**Code Technology Committee  
2006/2007 Cycle  
Area of study – Climbable Guards  
Public comments**

RB103: Page 1  
RB104: Page 2  
RB105: Page 3  
RB106: Page 4  
E96: Part I (IBC) – Page 6; Part II (IRC) – Page 11  
E98: Page 13

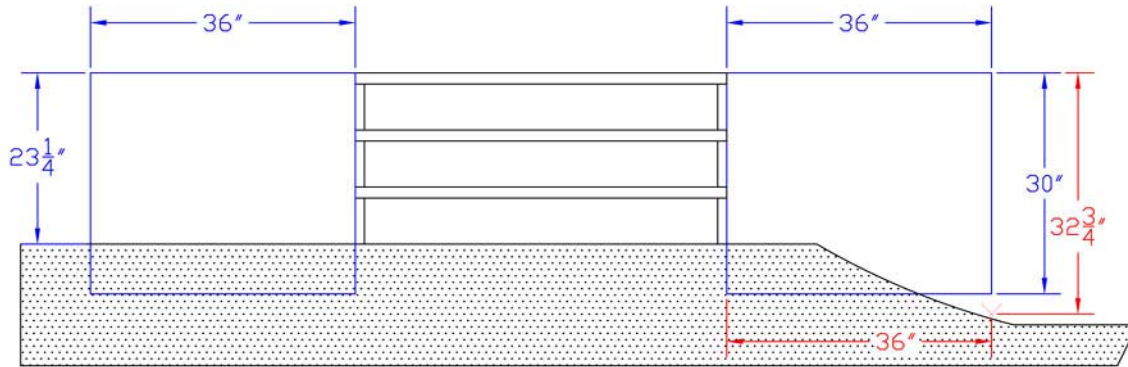
**Committer's Reason:** The code change committee sites in their reason that this issue is a "work in progress". While this is true regarding the CTC's review of the subject of climbable guards as far as testing, the CTC has concluded its review and solicitation of comments on the subject matter included in this proposal. The following revisions are proposed in response to the code committees concerns:

IBC 1013.1 Height measurement: This public comment is submitted in order to clarify how the height measurement which triggers the guard requirement is made relative to proximity to the adjacent fall-off. This is illustrated in the following figure:

The view is taken from the landing of a 3 riser stair, looking towards the face of the risers.

**1013.1 Where required.** Guards shall be located along open-sided walking surfaces, including mezzanines, industrial equipment platforms, stairs, ramps and landings, that are located more than 30 inches (762 mm) measured vertically to the floor or grade below at any point within 36 inches ( 914 mm) horizontally to the edge of the open side above the floor or grade below. Guards shall be adequate in strength and attachment in accordance with Section 1607.7.

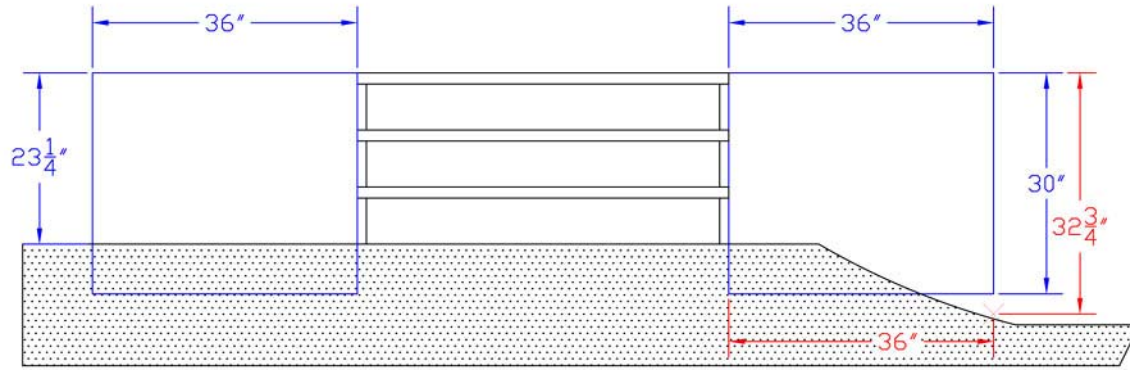
IRC R312.2 Height measurement: This public comment is submitted in order to clarify how the height measurement which triggers the guard requirement is made relative to proximity to the adjacent fall-off. This is illustrated in the following figures:

The view is taken from the landing of a 3 riser stair, looking towards the face of the risers.

**R312.1 Where required.** Guards shall be located along open-sided walking surfaces, including porches, decks, balconies, mezzanines, stairs, ramps and landings, which are located more than 30 inches (762 mm) ~~above the floor or grade below~~ measured vertically to the floor or grade below at any point within 36 inches (914 mm) horizontally to the edge of the open side. Insect screening shall not be considered as a guard.

**R312.2 Height.** Guards at open-sided walking surfaces, including stairs, porches, balconies or landings, shall be not less than 36 inches (914 mm) high measured vertically above the adjacent walking surface, adjacent fixed ~~seat boards~~ seating or the line connecting the leading edges of the treads.
